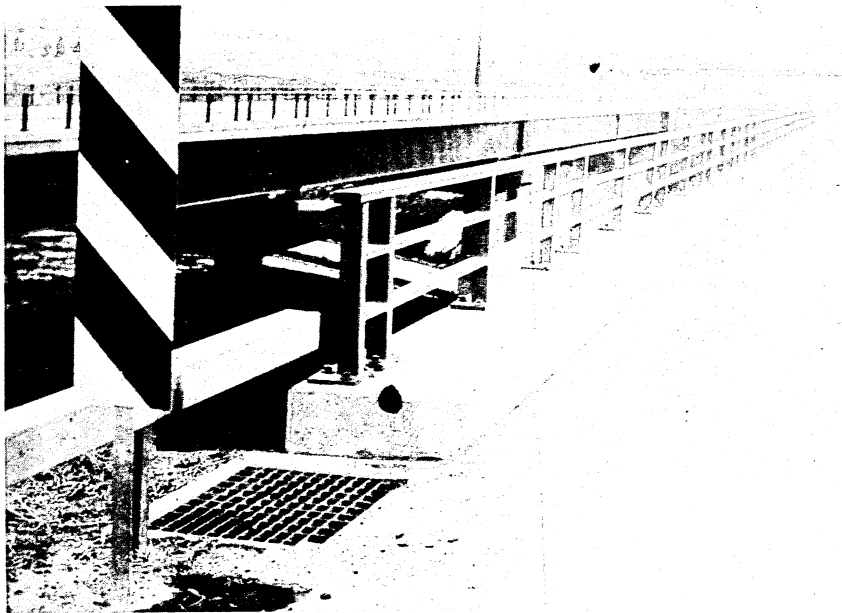
Mr. GRAHAM. Is the red spot symbolic?

Mr. W. MAY. Well, I suppose. It seems that we could make a better transition from the end of this box beam.

Mr. W. MAY. Yes. And that curb also presents problems.

Mr. McEWEN. Mr. Chairman, I would like to ask Mr. Graham a question. Should that reflector post be located inside of the traveled portion of the highway and inside of that guardrail?

Mr. McEWEN. Now, are there any directives in regard to a situation like that, whether that reflector should be inside or outside of the guardrail?

Mr. McEWEN. Mr. McAlpin, you would agree there is some degree of a hazard to that inside the box beam?

Mr. GRAHAM. Yes, sir; we have a transition section.

Mr. GRAHAM. We are now sweeping the curb away on a shallow angle and it passes under the approach barrier.

Mr. GRAHAM. I believe it would be preferable, sir, to put it on the opposite side. It is lightweight and would probably not present a particular hazard, but I would say it should be on the other side of the rail.

Mr. McALPIN. I do not believe that there are instructions that are that specific for this particular installation. I would not agree that there should not be, but as existing today, I do not believe there is.
